NOAA FORM 76-35A	
U.S. DEPARTMENT OF COMMERCE NATIONAL OCEANIC AND ATMOSPHERIC ADMINISTRATION NATIONAL OCEAN SURVEY	
DESCRIPTIVE REPORT	
<i>Type of Survey</i> Hydrographic	
<i>Field No.</i> HSB-10-2-82	
<i>Office No.</i> H-9996	
LOCALITY	
<i>State</i> Florida	
<i>General Locality</i> Gulf of Mexico	
<i>Locality</i> Entrance to St. Joseph Bay	
1983	
CHIEF OF PARTY LCDR G.W. Jamerson	
LIBRARY & ARCHIVES	
DATE April 5, 1984

DESCRIPTIVE REPORT
TO ACCOMPANY
HYDROGRAPHIC SURVEY H-9996
HSB-10-2-82

ATLANTIC MARINE CENTER
EVALUATION REPORT

REGISTRY NO.: H-9996

VELOCITY CORRECTIONS

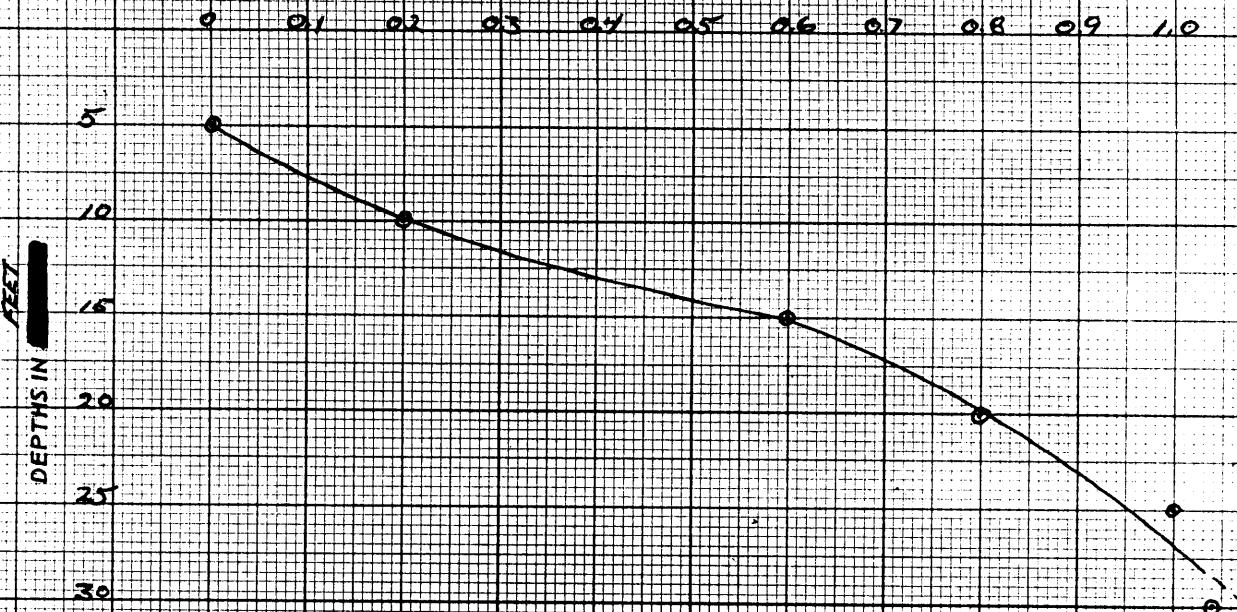
DO NOT USE THIS GRAPH.
SEE FOLLOWING GRAPH.

VELOCITY TABLE PRINTOUT

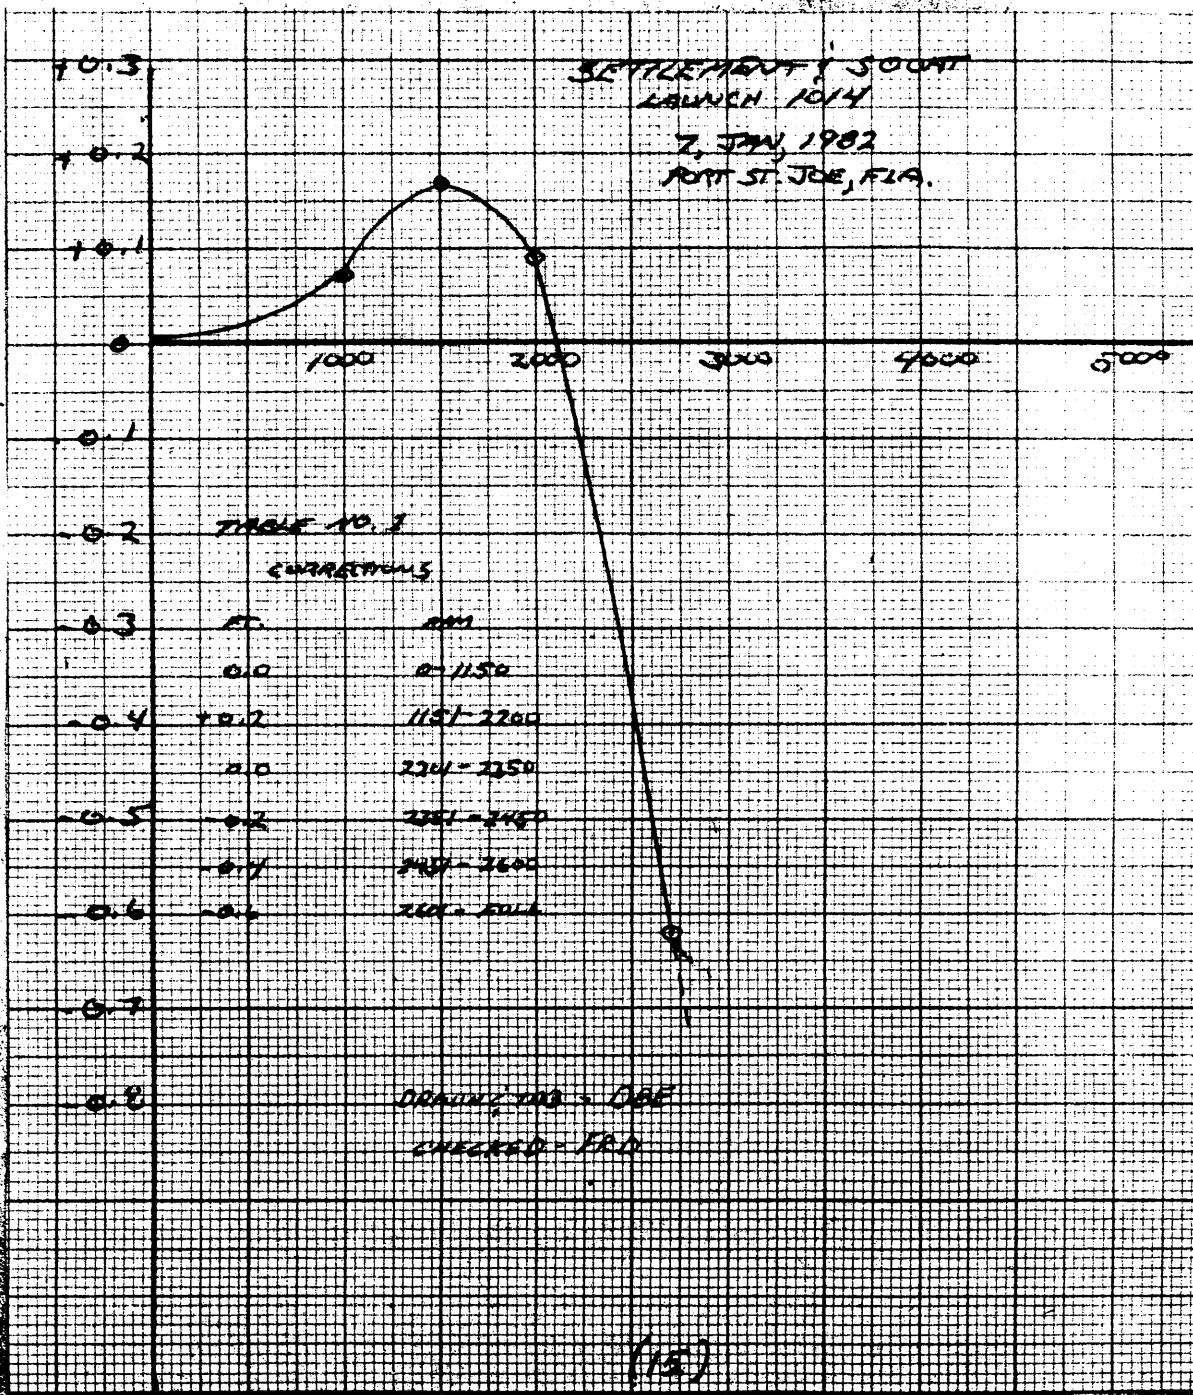
Do not use BAD Correctors. L.S.

Correct ones-L.S. ame-
